## SUMMARY OF ENERGY STRATEGY

**Energy Strategy: Response to  
Element Energy (July 2020, V3)**

**Energy Strategy:  
Response to Element  
Energy**

# **Vastern Road**

**Figure 2 – Total Annual Costs**

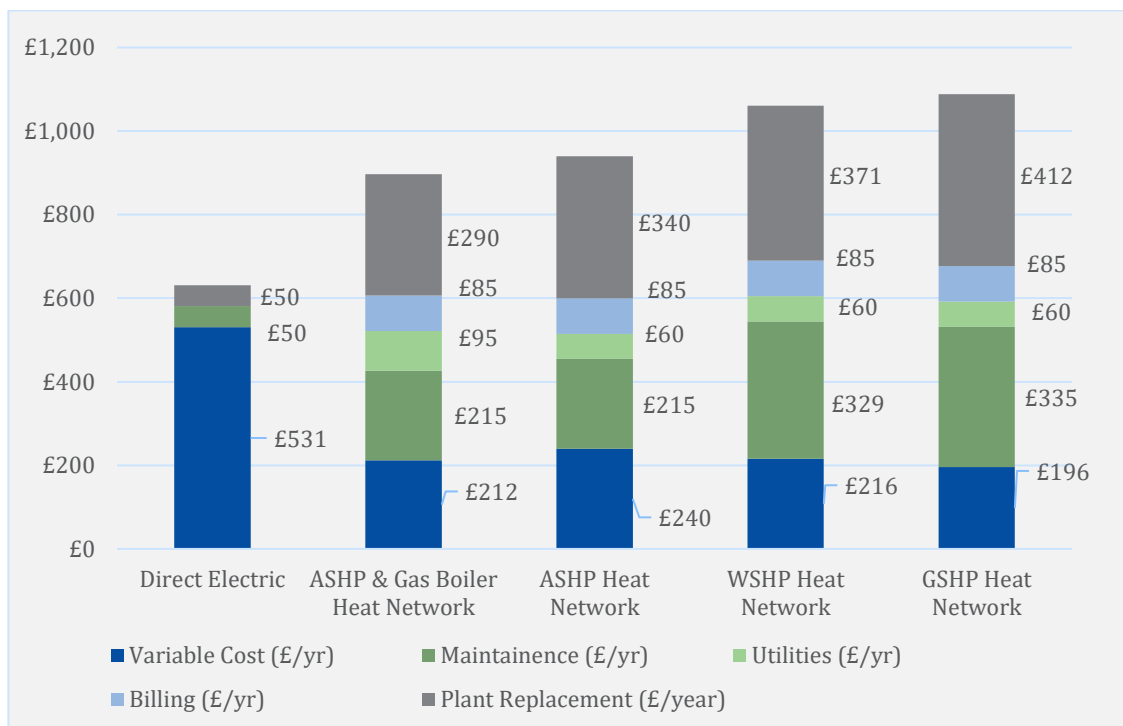
2.6 A summary of the total resident costs from lowest to highest is as follows:

- > Individual – direct electric - **£631/yr**;
- > Heat Network – heat pumps (air source) and gas boilers - **£897/yr** (42% increase);
- > Heat Network – heat pumps only (air source) - **£940/yr** (49% increase);
- > Heat Network – heat pumps only (water source) - **£1,061/yr** (68% increase);
- > Heat Network – heat pumps only (ground source) - **£1,088/yr** (72% increase).

- 2.8** It is shown that although heat consumption costs (variable) are lower for all heat network scenarios, the much higher fixed costs mean that overall residents are expected to be paying at least 40% more in heating costs than the proposed direct electric system. An open-loop GSHP could result in costs which are as much as 70% higher.
- 2.9** This analysis has been repeated for instances where the dwelling heating demands may be 50% higher or 50% lower than anticipated through SAP calculations, or where heat network losses would be much lower. These results are shown in Appendix B, and demonstrate that under each of these conditions direct electric heating still represents the most cost-effective system for residents.
- 2.10** No Renewable Heat Incentive payments have been assumed due to the risk that any plant will not be commissioned before March 2022.

**Figure 3: Borehole Data** (<http://mapapps.bgs.ac.uk/geologyofbritain/home.html>)

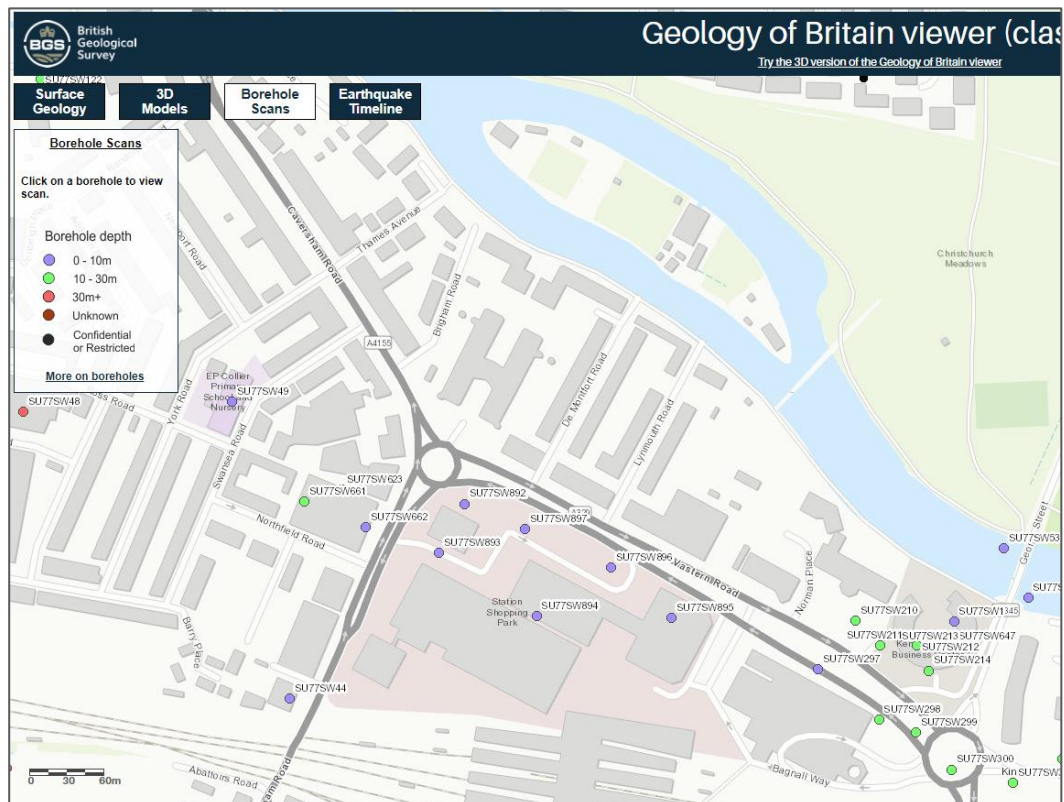
- 3.16** There are no existing borehole records within the vicinity of the site at a depth of more than 30m available from the British Geological Survey website (Figure 3, below).

- 3.17** In order to determine the suitability of the site for open-loop GSHPs, a detailed feasibility assessment would be required which would involve the drilling of test wells and close liaison with the Environment Agency. This would determine available heat yields, as well as data on water quality and therefore filter requirements, both of which can significantly impact capital and operational costs of such systems.

drawing  
Closed-Loop GSHP Available Area Study

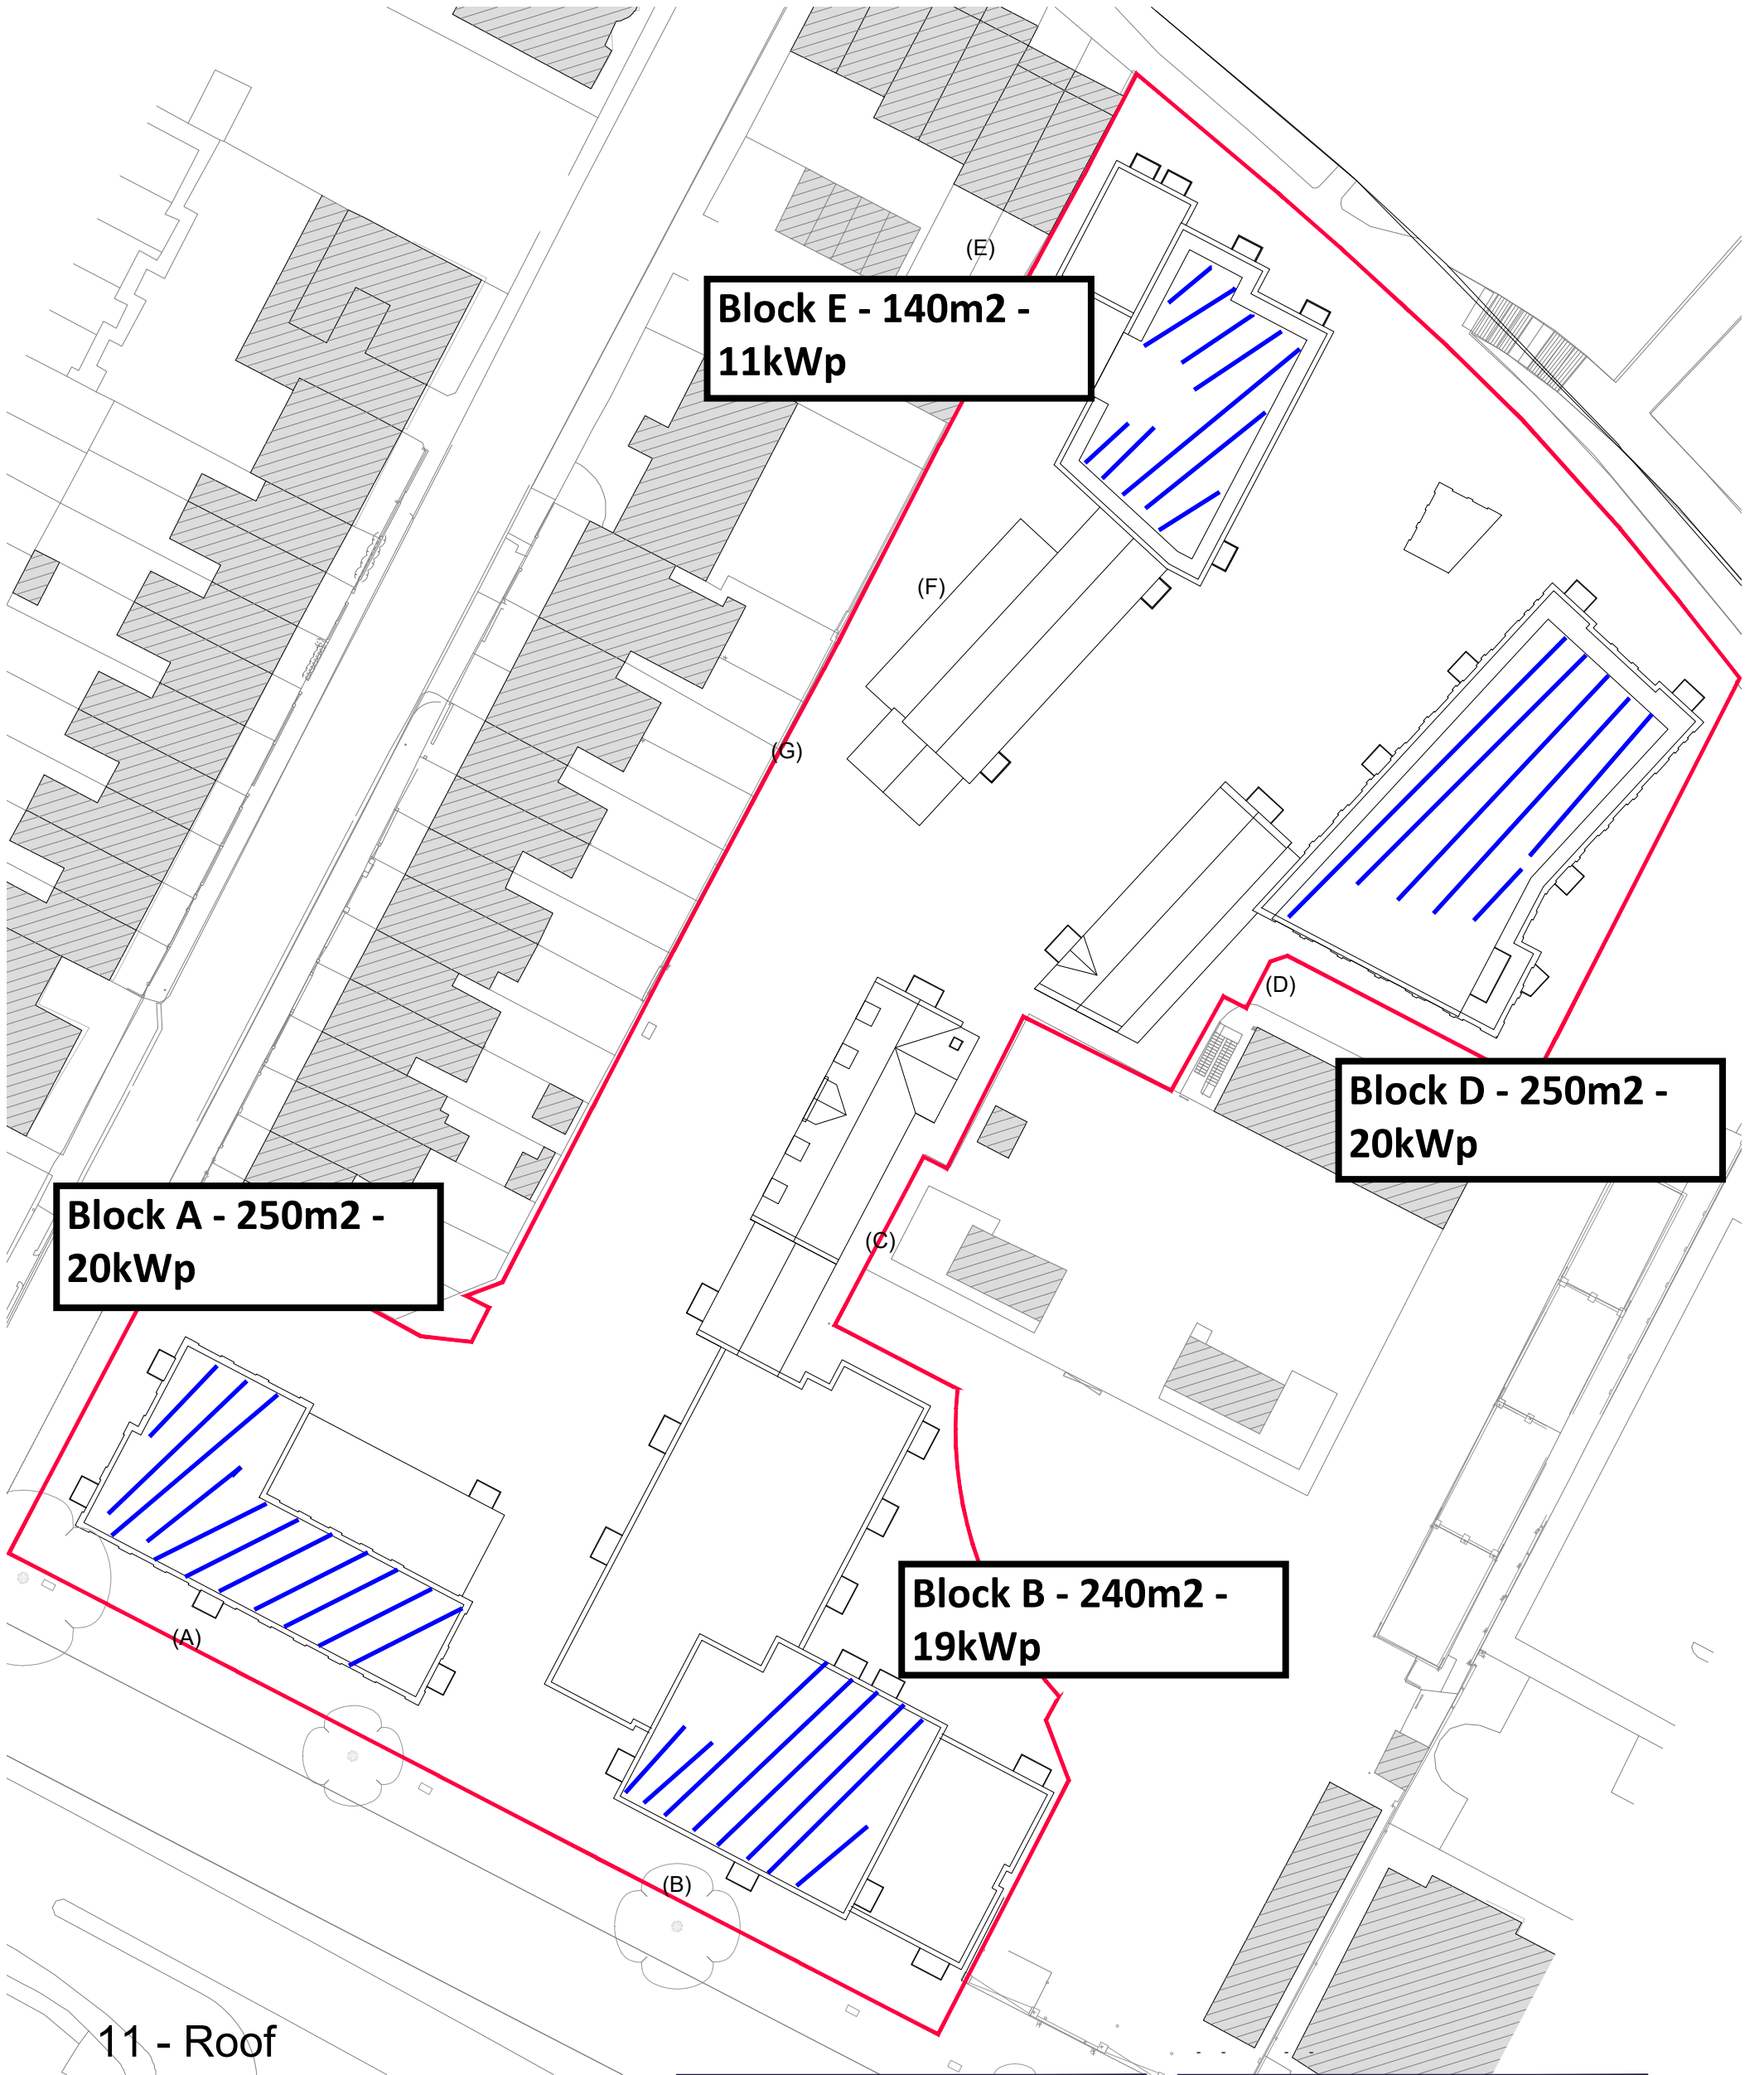
- > There is insufficient suitable space for the installation of the estimated required number of boreholes for a closed-loop GSHP system. This was shown in a site plan provided in Appendix C of the Response to Element Energy report, with explanation provided in points 3.8 – 3.12;

- 3.8** A site-specific thermal response test would be required as part of any detailed early stage feasibility works. This would determine the exact number of boreholes required, as well as their depth and spacing.
- 3.9** Initial rules of thumb suggest that between 50 and 80 boreholes would be required to deliver 365kW heat output from a ground source heat pump. This would result in a requirement for approximately 2,500 – 4,000m<sup>2</sup> land area based on an initial spacing exercise.
- 3.10** Element Energy noted in their report how a closed-loop GSHP system is likely to require an area which covers 3-4,500m<sup>2</sup> at Vastern Road, which was acknowledged as challenging given the spatial constraints of the site.

- 3.11** The high number of boreholes, trenching and overall space required for a closed loop GSHP system mean that this solution is not a possibility for a dense site such as Vastern Road. The total site area which has been deemed appropriate for the installation and ongoing access of boreholes is 1,939m<sup>2</sup>. This is significantly lower than the lowest spatial requirements estimated by both Element Energy and Hodkinson Consultancy, and an 8m spacing between boreholes could not be achieved. A site plan showing the available area has been included in Appendix C.
- 3.12** The ground on and around the development also has a contamination risk, due to the site previously hosting a power station. This presents a further complication.

**Figure 1: Estimated Resident Heat Costs (£/yr)**

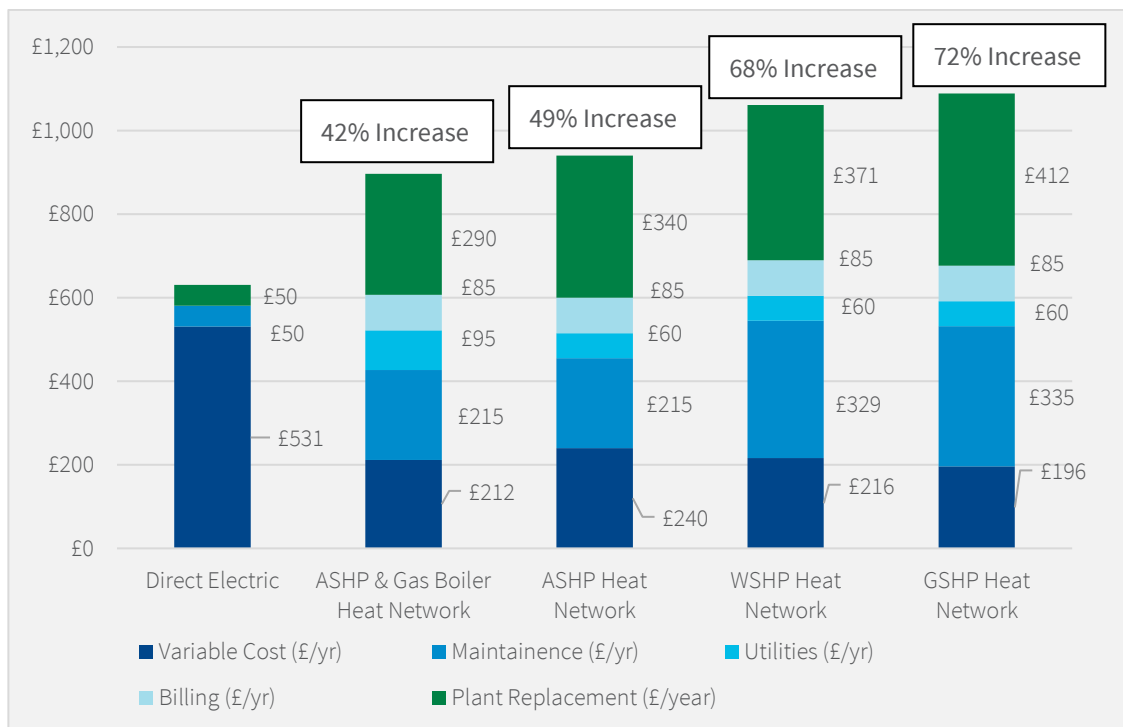
The position put forward to Reading Borough Council and their appointed energy consultants, Element Energy, is that a heat pump-led site heating network for the Vastern Road development would result in unacceptably high costs to residents. The graph, below, was provided with supplementary explanation in the report issued in July.

It can be seen from Figure 1 that maintenance costs for a network of 209 connections for all heat pump scenarios are relatively high. Further detail is provided below as to the key components which cause this.
